Re: Baker River Hydroelectric Project, FERC No. 2150; Settlement Errata for the Settlement Agreement Dated November 30, 2004

Baker River Hydroelectric Project Relicensing Comprehensive Settlement Agreement

Errata Pages Only

Article 301 Recreation Management Report

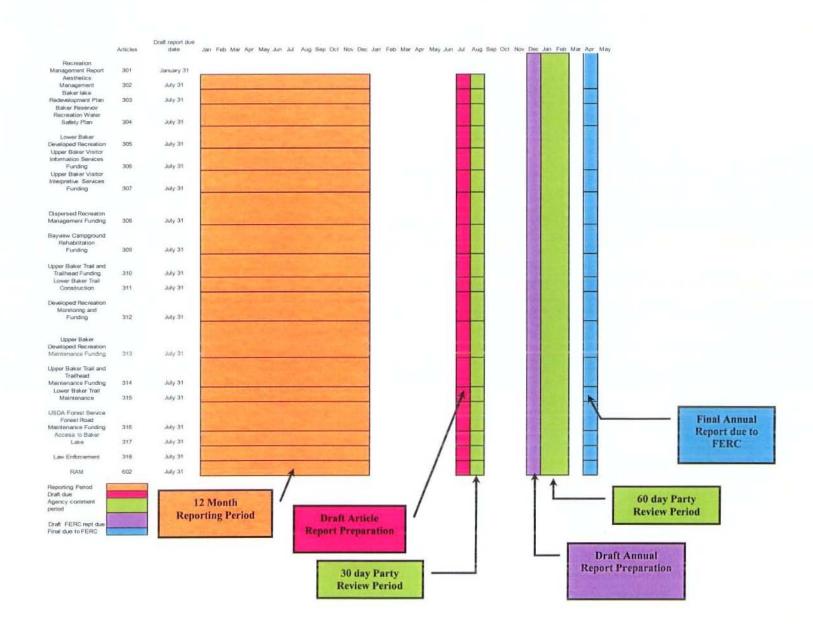
- Proposed Article 301: Clarifying language on content of RMR submission, second paragraph of 301, plus corrected Reporting Schedule that includes all articles in 300 series.
- Proposed Article 501: Text correction deleting reference to non-existent article
 518, plus corrected Reporting Schedule that includes all articles in 500 series.
- Proposed Article 504: Clarification adding "(b)" reference to cross referenced article (505) in first paragraph.
- Proposed Article 508: Deletion of last sentence, inadvertently included in final filing by mistake.
- Appendix A-5, Revised Recreation Implementation Schedule, corrected to revise inadvertent errors in Settlement filing.

For license Articles 301-318 and 602, licensee shall provide an annual summary of expenditures made during the preceding year in conformance with the requirements of the license, as well as an accounting of funding expenditures, interest earned, disbursements made as required by any article, and a report indicating adjustments made for inflation in accordance with Article 602. The figure below depicts the annual reporting schedule.
